# Approach Permit & 911 Address Form

<b>Applicant/ Property Owner:</b> Glen Ullin Energy Center, LLC			<b>Current Mailing Address:</b> 30 W Superior St, Duluth, MN 55802			
<b>E-mail Address:</b> jhollingsworth@allete.com			<b>Daytime Phone or Cell #:</b> 218-355-3249			
<b>Lot:</b>	<b>Block:</b>	<b>Subdivision:</b> Approach #3 Coordinates: 46.981275, -101.827835	<b>Quarter:</b> NE 1/4	<b>Section:</b> 6	<b>Twp:</b> 140	<b>Rge:</b> 88

APPROACH - 20' WIDE TOP MINIMUM

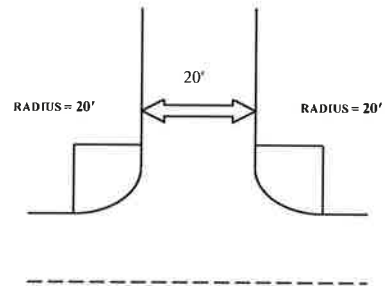
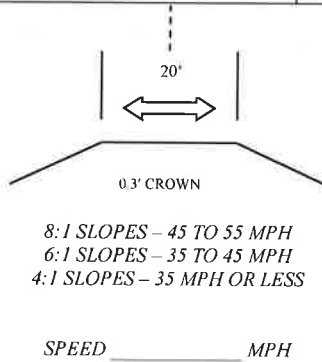
**Culvert Comments:** *At time of construction place a minimum of 1 foot fill over pipe and increase culvert length to correspond with desired approach top over 20 feet.*

**Approach Comments:** (Sight Distance? Problems? Etc.) *At time of construction place 4 inches gravel on approach.*  
*Inslope work required for 8:1 slopes*
